Clinch River Nuclear Site  
NRC Docket No. 52-047

Subject: Response to Request for Additional Information RAI Number 3, eRAI-8893,  
Regarding Vibratory Ground Motion in support of Early Site Permit Application for  
Clinch River Nuclear Site

### **Response to NRC Request for Additional Information Number 3, eRAI-8893**

**Figure 2.5.2-107. Comparison of 1D (Base-Case Profile) and 2D Amplification Factors (PSA, 5% Damping) for Location A**

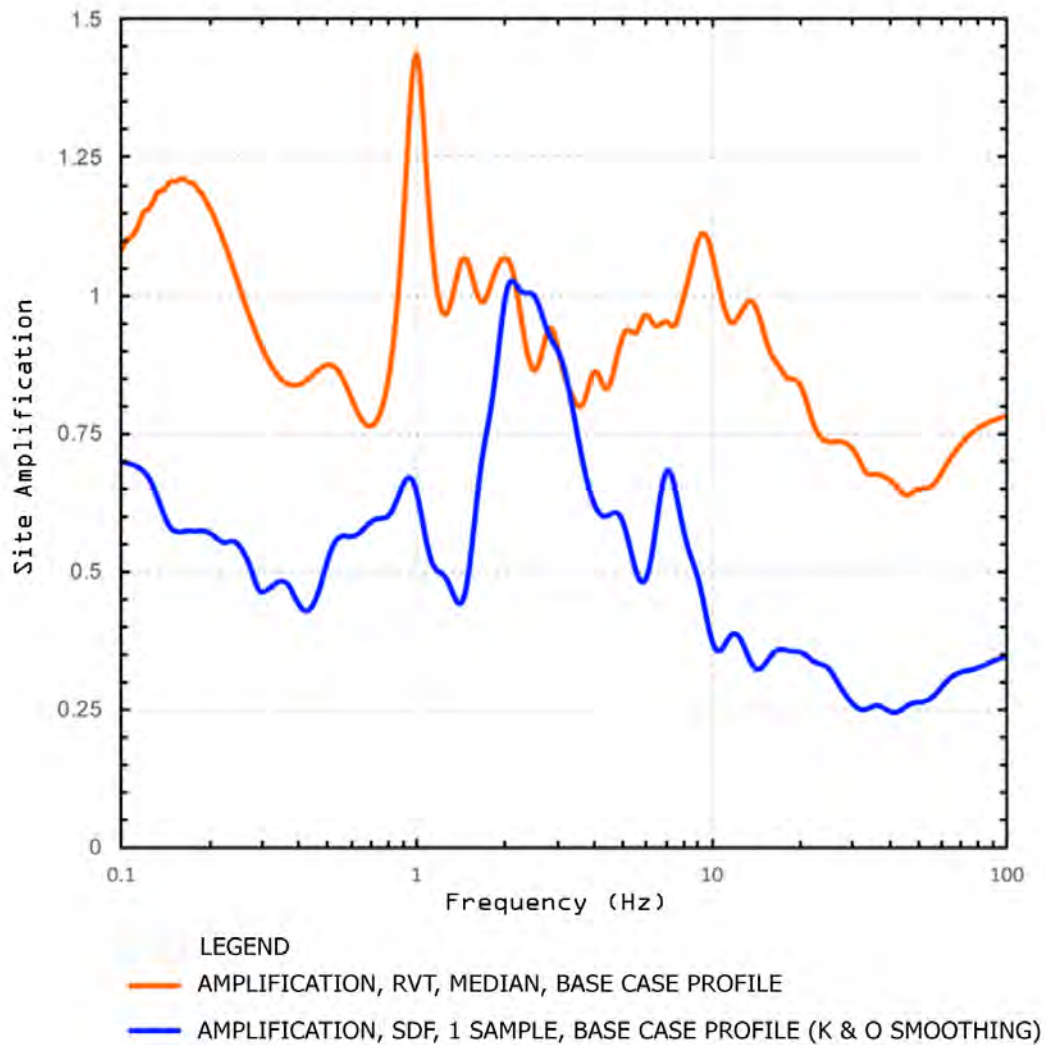
*Section 2.5.2.6 of the SSAR provides the results of a sensitivity study evaluating the potential impact of 2-D site effects on site response. This sensitivity study includes a comparison of the 2-D site response and a 1-D site response using a similar approach used for the 2-D results. However, the 1-D site response used in this comparison is not used for establishing the permit basis of the Clinch River site. The comparison presented in the SSAR does not currently show that the 1-D site response used for licensing adequately captures the 2-D site effects explored by the sensitivity study.*

*In order to satisfy requirements in 10 CFR 100.23(d)(1) as it relates to seismic hazard and for the staff to make a determination about the adequacy of the 2-D sensitivity study, please provide a comparison of the 2-D site response to the 1-D site response results used to establish the Clinch River site GMRS.*

SSAR Subsection 2.5.2.6, "2D Sensitivity Analysis," is being revised to provide additional detail regarding the 1D amplification used in the development of the Clinch River GMRS as compared to the 2D sensitivity analysis. Additionally, Figures 2.5.2-107, 2.5.2-108, 2.5.2-109, and 2.5.2-110 are being added to detail the comparison of the 1D base case profiles to the 2D amplification factors for Locations A and B. The overall conclusions regarding 2D effects for the Clinch River Site have not changed. See the SSAR markups provided in Subsection 2.5.2.6 in Attachment 1.

Figure 2.5.2-107 compares the 1D amplification used in developing the GMRS with the 2D sensitivity analysis for Location A. In Figure 2.5.2-107 the 1D amplification factors shown are for the base-case profile and reflects the median estimate over 60 realizations. Since the 2D sensitivity calculation represents only a single analysis or realization, it has been smoothed using the Konno and Ohmachi algorithm (Reference 2.5.2-211) to reflect similar resolution as the 1D median estimate.

As Figure 2.5.2-107 illustrates, the 1D amplification factors significantly exceed the smoothed 2D factors computed in the sensitivity analysis across all frequencies except for a narrow frequency range around 2 Hz. Figure 2.5.2-108, illustrates the broadening of the 1D amplification by including the median amplification for the lower- and upper-range profiles.
